ANNEX B-1. DRAFT VALUE ENGINEERING REPORT

CENTRAL EVERGLADES PLANNING PROJECT FEASIBILITY PHASE

VALUE ENGINEERING STUDY REPORT

February 2013

A-2 FEB Location Map

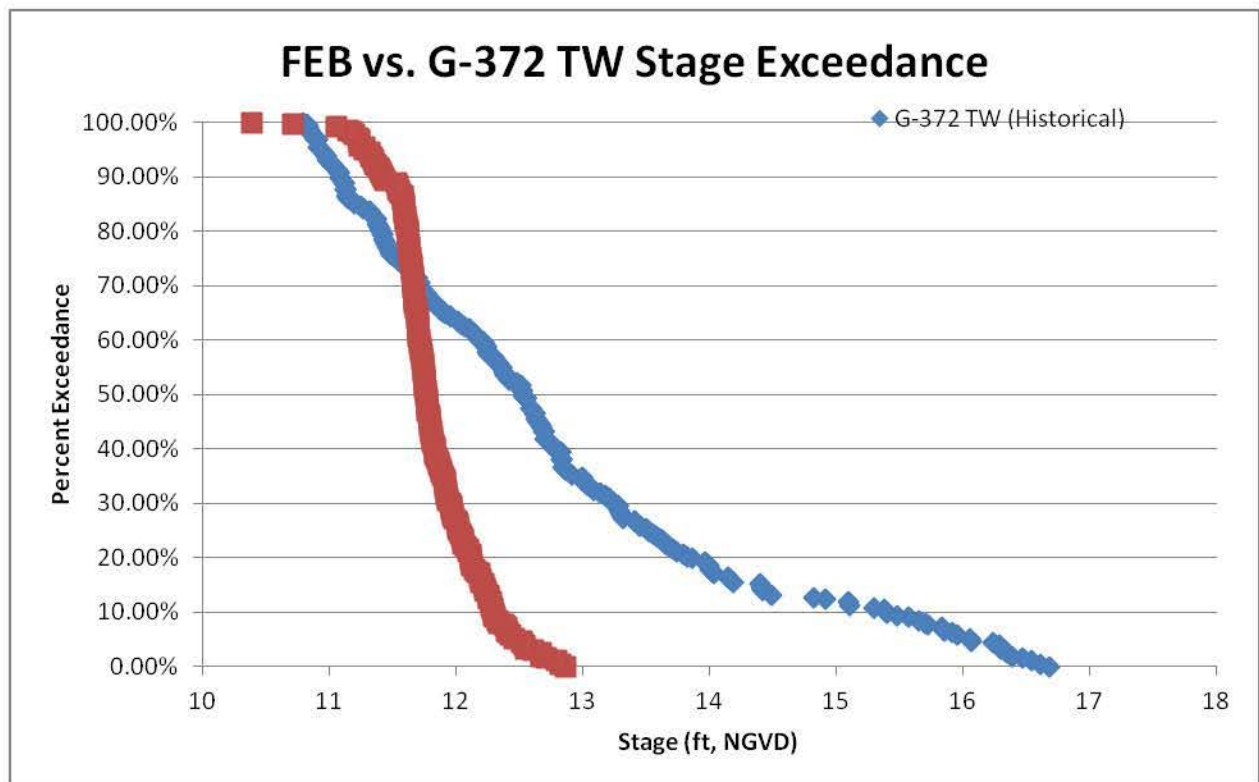
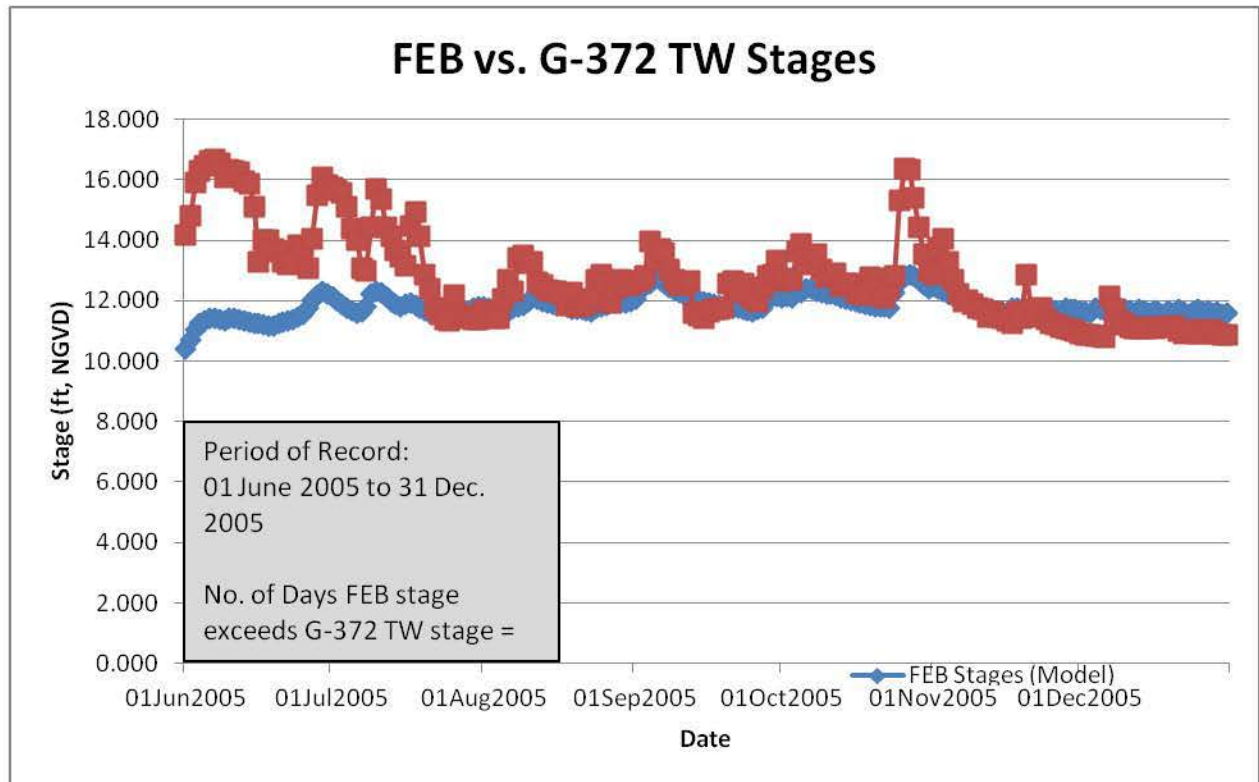
NR-1 Add outflow gravity structure on SE corner of A-2 - The currently proposed design of the A-2 FEB has one outflow structure, DS-7, located on the western perimeter discharging via an outflow canal to the headwaters of G-372. G-372 will be responsible for providing the lift to convey the discharges through the STA 3/4 Supply Canal toward the STA 3/4 inflow structures. A recommendation was made to place gravity outflow structures along the southeast corner of A-2 (see map below). This would be possible as long as the stages in STA 3/4 Supply Canal were low enough for water to pass from the FEB (max stage of 13.0 NGVD – natural grade at 9.0 NGVD with 4 ft depth). The STA 3/4 Supply Canal design stages for HW (G-372 TW) and TW (STA 3/4 Inflow structures HW) are 17.0 NGVD and 15.0 NGVD, respectively.

Using the same period of record (01-June-05 to 31-Dec-05) to compare historical G-372 TW stages and modeled FEB stages, data shows that FEB stages exceed G-372 TW stages on average 0.42 ft for a total of 68 days out of 214 days (31.78%). If the proposal is adopted, structures would most likely be culverts with flap gates (reference below graphs).

Preliminary disposition: Address recommendation in project design phase.

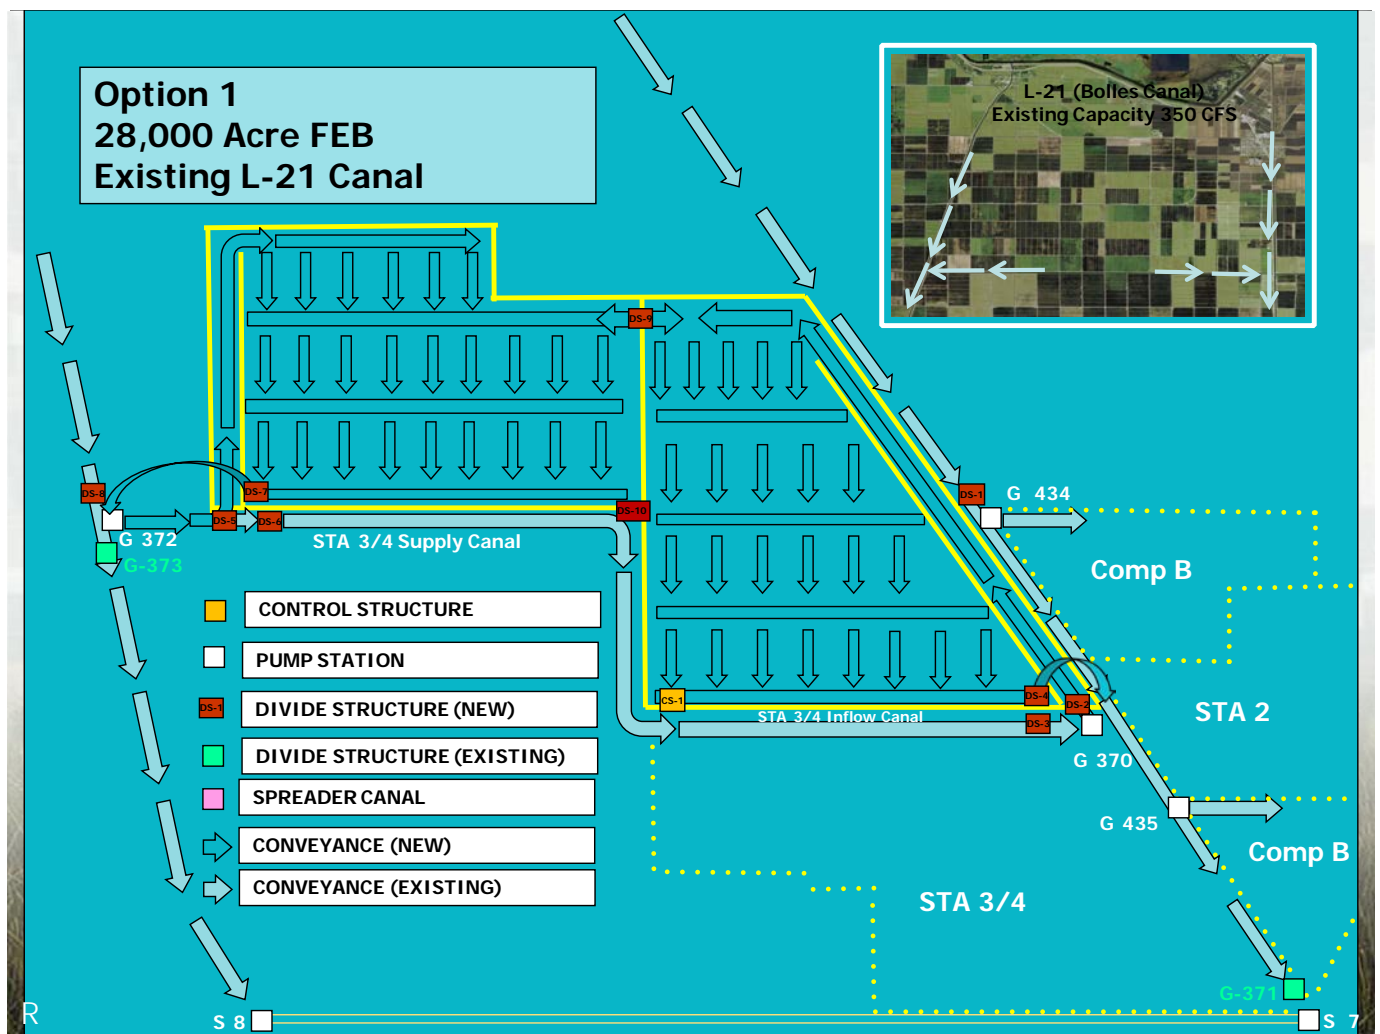
NR-2 Add in-line structure for North New River Canal - The structure in the North New River Canal is an in-line structure that would be located just north of Compartment B, upstream of Pump Station G-434. (See DS-1 in Figure below.) It would allow water from the A1 and A2 FEB's to be discharged into the North New River Canal without mixing with untreated water. At that point, treated water could either be pumped into Compartment B or STA 3/4 for further treatment. Initial modeling results indicate that DS-1 may not be needed for A1 to function, but further modeling and design of the A-1/A-2 FEB combination may indicate that DS-1 is needed.

Preliminary disposition: Address recommendation in both current plan development and project design phase.

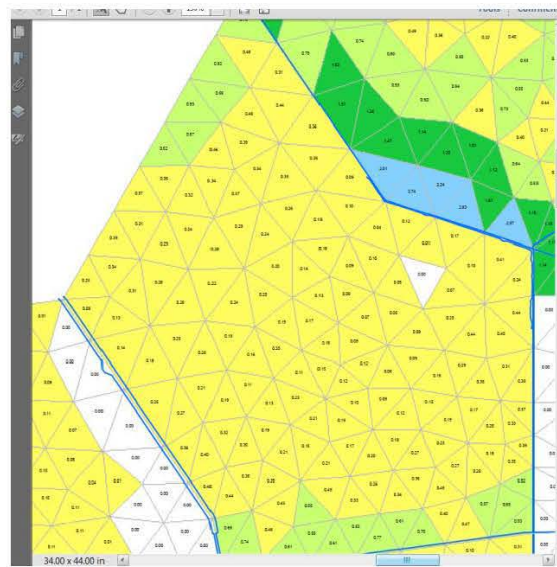
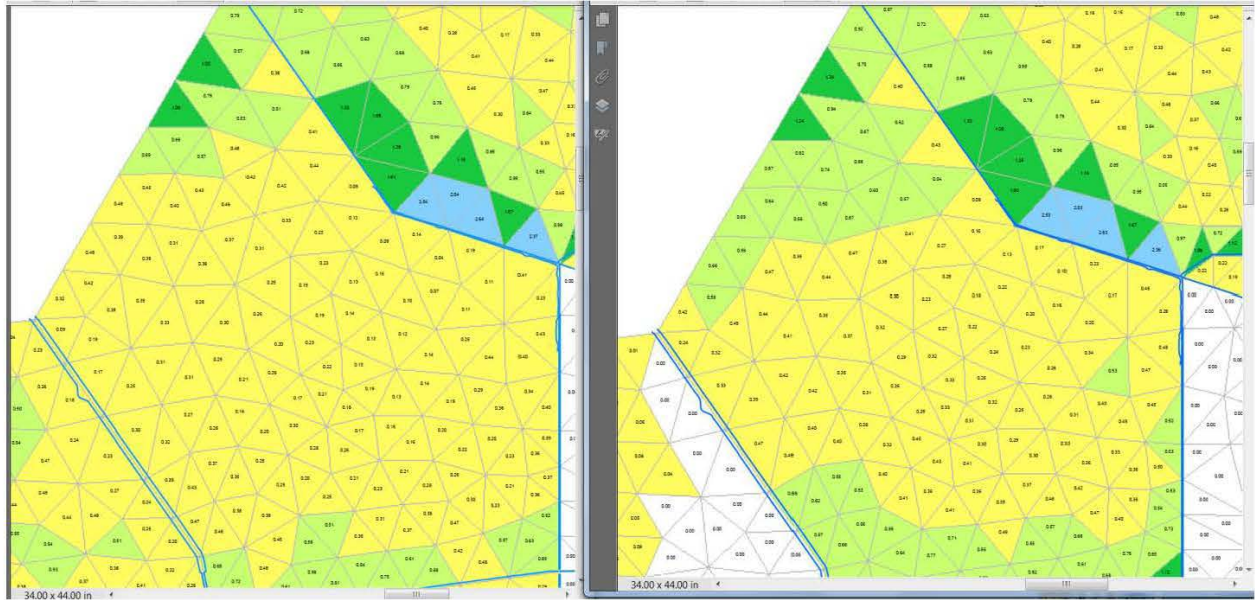
SR-1 Add AM strategy for G-336G (L6 Diversion) - As part of the CEPP TSP, L-6 diversions of STA treated water that normally would go to WCA 2A would be routed to the L-5/L-4 canals for distribution in WCA 3A. This results in unintended consequences to lowering WCA 2A (see ponding figure in dry season below) and can result in risk of dryouts and fires beyond what it currently experiences. G-336G (see pictures below) is a structure along the L-6 levee in between the EAA and WCA 2A that could potentially be used or retrofitted to help add water during dry periods to avoid drying out of WCA 2A beyond the existing conditions. The structure needs to be examined to determine whether it is controllable to move water northeast or and southwest over a variety of conditions in the canal.

Preliminary disposition: Address recommendation in both current plan development and development of the Adaptive Management Plan.

Figure1. Draft targets above represented as black line on existing 2A stage hydrograph (stage in NGVD on y-axis, water depth on x-axis).

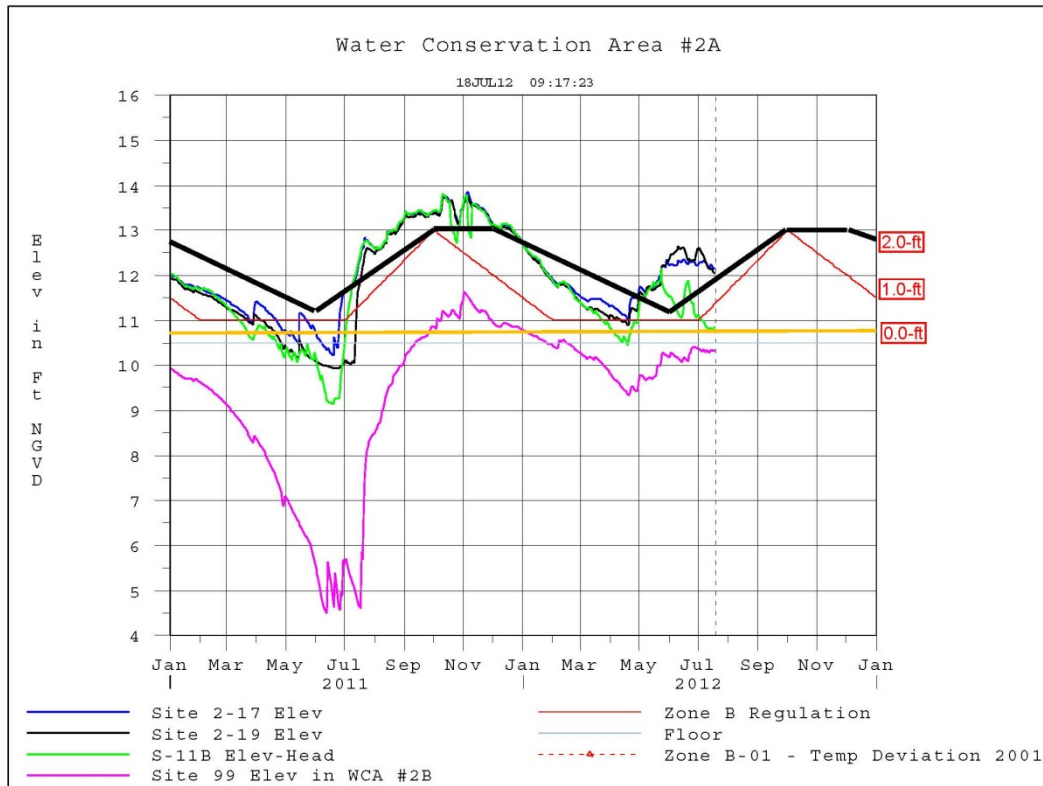
Purpose: To provide ecological targets and draft stage hydrograph (Figure 1) that more closely resembles an environmentally preferred *water management strategy for WCA-2A* (not intended to change the 2A regulation schedule).

1. Dry Season Low Recommended Depth Range (~June 1st): **0.0 – 0.5-ft**
2. Wet Season High Depth (~Oct 1st): Approximately **2.0 – 2.25-ft**
3. January 1 target depth range: ~**1.8-ft**
4. Recession Rate Guidelines (January 1- June 1): **0.05 ft/wk** (snail kite preferred) – **0.07 ft/wk** (wood stork and state listed wading birds).
5. Ascension Rate Guidelines (June 1 – Oct 1) Maximum of **0.25 ft/week** and approximately **0.05 ft/wk** minimum. Preferred **0.05-0.15-ft**.

Assumption: Ground surface elevation of 10.75-ft NGVD (EDEN Wet Prairie Site 17). Ultimately, WCA-2A will need to join the periodic scientist calls for real-time water management with ecological recommendations for recession rates, ascension rates, and core foraging depths.

Preliminary disposition: Address recommendation in development of Adaptive Management Plan.

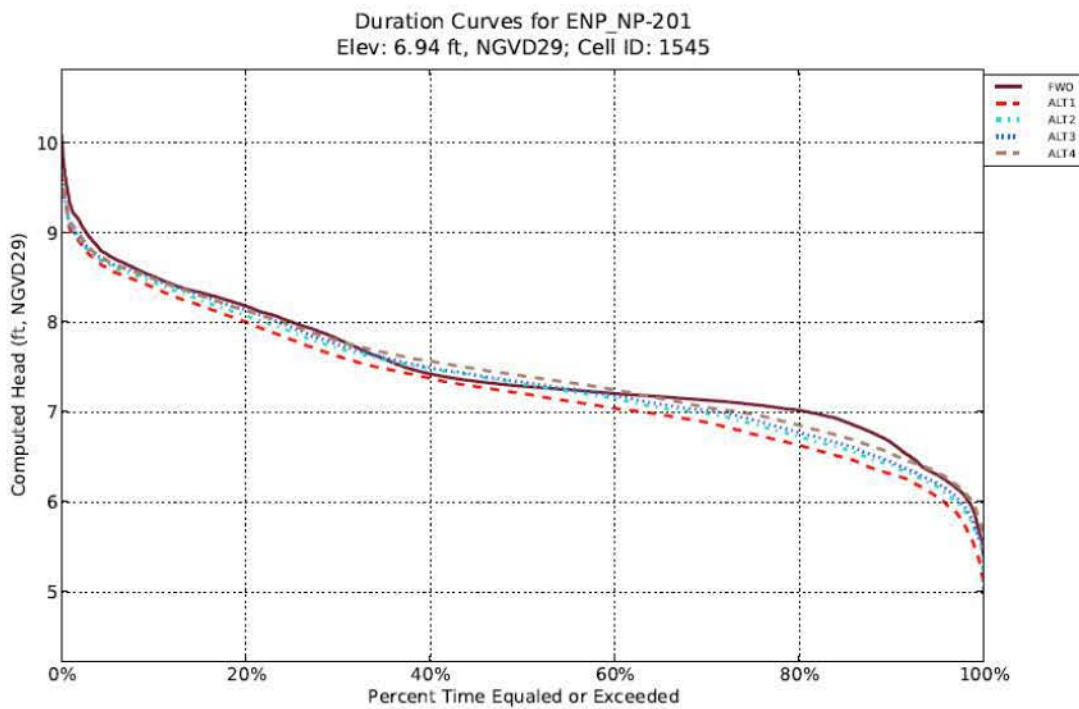
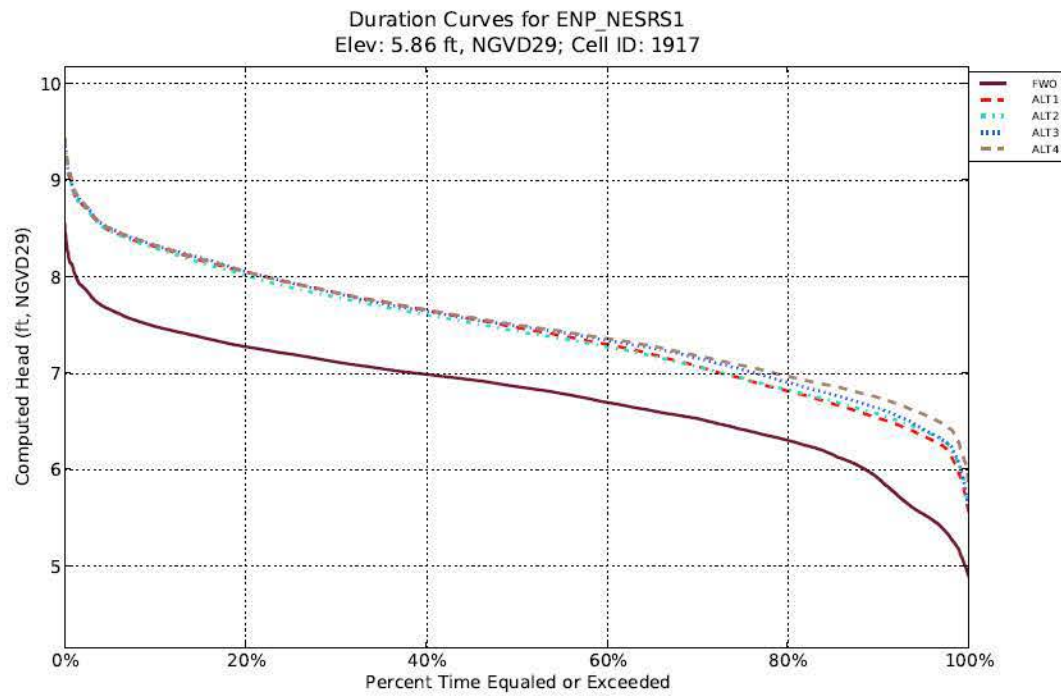
Option 1: Remove of 1.5 miles of the L-67 Extension Levee and Canal (modeled CEPP Alternative 1). Removal of ~1.5 miles of the L-67 Extension Canal is anticipated to negligibly affect the outlet conveyance capacity of the S-12C and S-12D (previously considered with the MWD Project), and would not likely require mitigation through removal of all or portions of this section of the Old Tamiami Trail. This option would provide reduced hydrologic connectivity between Western SRS and Northeast SRS, as compared to the TSP (although greater than the No Action condition). Depending on the CEPP flow distributions within other parts of the system, which is still being adjusted with ongoing modeling, the stage differential between CEPP Alternative 1 (1.5 mile L-67 Extension removal) and CEPP Alternatives 2-4 (complete L-67 Extension removal) are negligible at NESRS-1 (see Alternative 2) and minor at approximately 0.1-0.2 feet at NP-201 (see accompanying figures). The performance-based TSP selection of Alternative 4 was not critically dependant on the L-67 Extension configuration. Option 1 is also a potential adaptive management increment.

Option 2: Remove most or all of L-67 Extension Levee and do not fill canal (not modeled in CEPP alternatives). This option would provide hydrologic connectivity between Western SRS and Northeast SRS, comparable to the CEPP TSP performance. A modest reduction in the outlet conveyance capacity of the S-12C and S-12D would be expected due to the increased hydrologic interaction between S-333 and the S-12s, although this may be offset with the significant reduced regulatory reliance on the S-12s with CEPP implementation (as modeled). Complete removal of the segment of Old Tamiami Trail would not be required and the L-67 Extension Levee material could be utilized for other CEPP components (i.e. Blue Shanty Levee), potentially with material processing requirements.

Preliminary disposition: Address recommendation in development of Adaptive Management Plan.

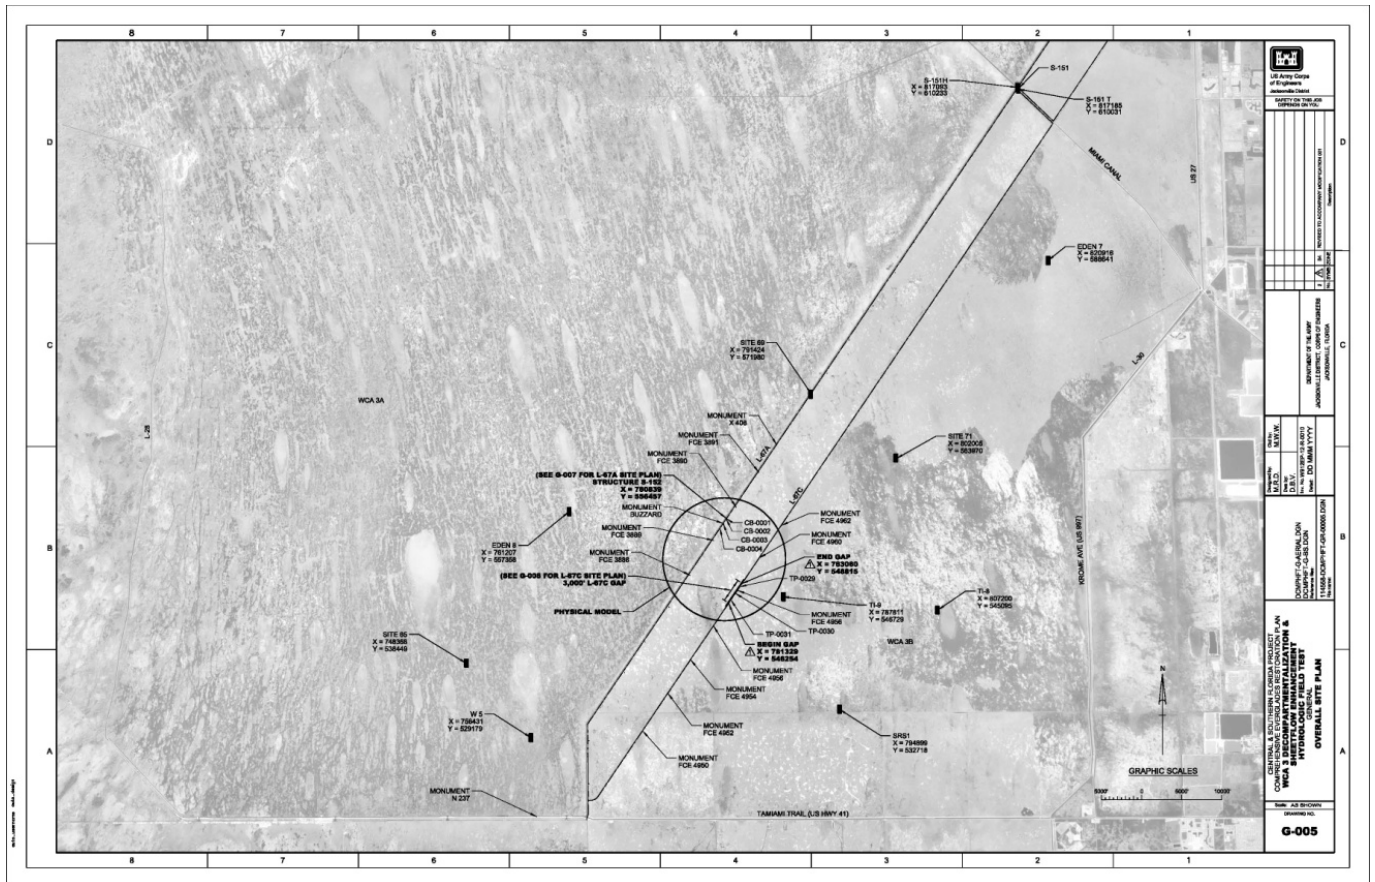
GB-5 Retrofit DPM structure (S-152 800 cfs 10 - 60" HDPE barrels); Use DPM structure for interim period - USACE and SFWMD entered in a design agreement May 12, 2000 for purposes of conducting activities related to planning, engineering and design of CERP projects. The Decom Physical Model known as DPM project was permitted as a large-scale field test designed to answer uncertainties with depth, hydroperiod, sheetflow and canal backfilling associated with the full-scale CERP DECOMP project. It was designed for a 5 year life cycle to go in place and be removed between 5-10 years as described in the DECOMP DPM Design Test Documentation Report. The DPM contract is scheduled for completion 2013. L-67C 3,000 ft gap was completed in Nov 2012. Plan is to conduct test for 2 years after construction complete for (2 months) of each year. Part of the permitting also conceptually approved de-installation (removal) of S-152, excavation of backfill material from L-67C canal, L-67A and L-67C levee reconstruction and finally removal of temporary access roads and spoil areas (see below drawing).

This VE recommendation proposes to retrofit the existing temporary (S-152 test structure) that was designed within the constraints noted above (design test, temporary nature, easily removable materials after test complete). A second part of this proposal is allow DPM components to remain in place and use it to continue to collect information through CEPP Adaptive Management. PROS – The existing temporary structure can be operated to see how 3B responds and what benefits you will achieve moving existing water through 3B and potentially the proposed flowway. CONS- maintenance responsibilities of the structure and functionality if left in place longer than the 10 year design life concept. It affects material selection as well as potential problems for seepage of the culverts. This idea is something that could merit consideration for the VE Report and further investigation during PED detail design phase.

Preliminary disposition: Address recommendation in both project design phase and development of the Adaptive Management Plan
